Motor Vehicle Safety
 Information: 1-800-333-0371

Ferrari Befix High Back Booster Seats – Shoulder Belt Guide Routing Instruction
 Revisions

Figure 2. U-Shaped Shoulder Belt Guide

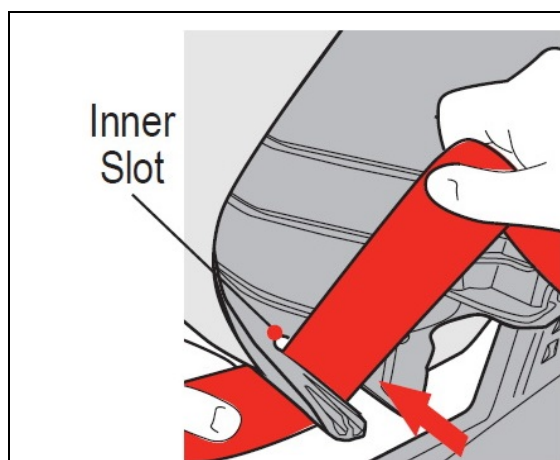
5514 KM Corporation has revised the instruction page to ensure that the instructions clearly describe the vehicle shoulder belt routing process.

Instructions: Thread shoulder belt into the inner slot of Booster Shoulder Belt Guide located on the underside of the Head Support. Slide shoulder belt into open end of slot.
